CITY PLANNING COMMISSION

- APPLICATION:**
- A. Negative Declaration
 - B. Plan Review of an 88-unit apartment complex on 5.8+ vacant acres in the Multifamily-Review (R-2A-R) Zone.

LOCATION: Jacinto Road, west of Center Parkway

PROPOSAL: The applicant is requesting the necessary entitlements to develop an 88-unit apartment complex.

TYPICAL DOUBLE MASTER & 1 BEDROOM BUILDING TYPE ELEVATIONS - TWO STORY (BUILDING TYPE II SHOWN)
 3/18 : 1-0

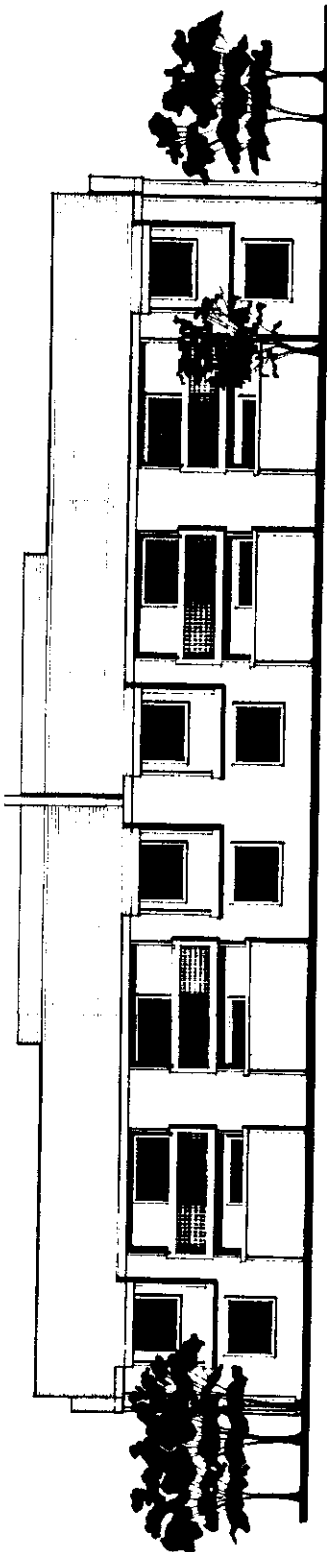
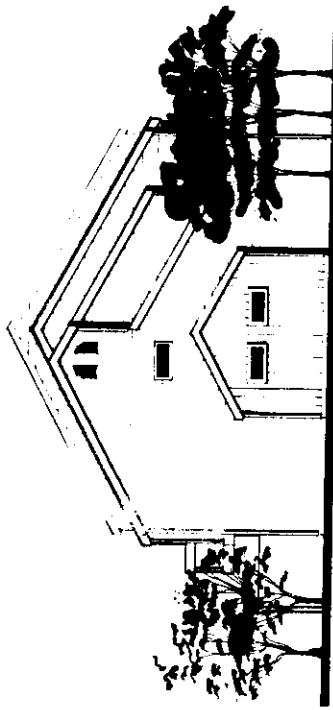
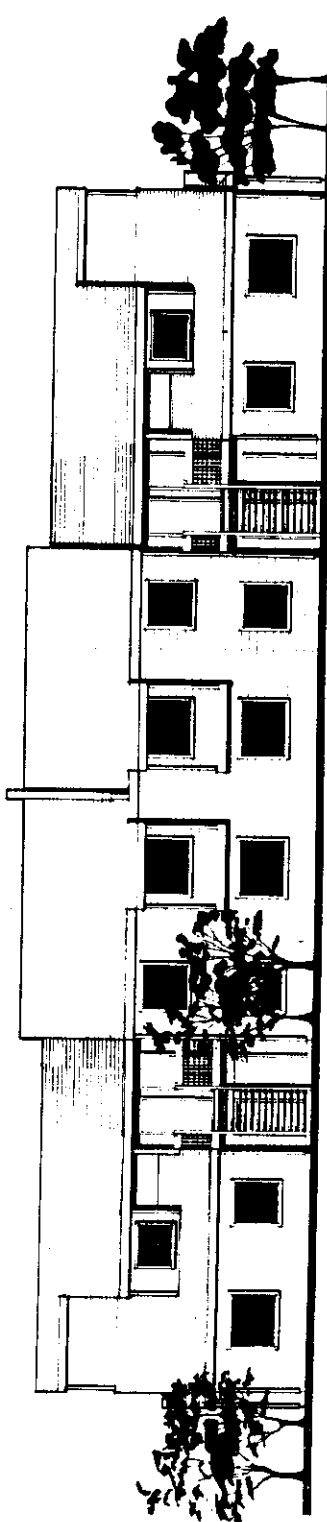
The applicant proposes building exteriors consisting of individual horizontal wood siding and composition shake roofs. Exterior colors proposed are a combination of grey, white, and blue. Staff recommends the use of smooth cedar wood shakes rather than composition shingles. The wood shakes are more aesthetically pleasing and present a higher quality project. Plans for the garages and covered carports have not been submitted. The garages and carports should be similar in design and materials to the proposed apartment units. The carports should contain a wood fascia treatment. Trash enclosures and bicycle storage facilities shall follow the guidelines outlined in the multi-family design criteria.

7. The contrasting decorative paving material within the project shall comply with the zoning ordinance.
8. The building elevations shall consist of individual board, horizontal wood siding with smooth cedar wood shake roofing material.
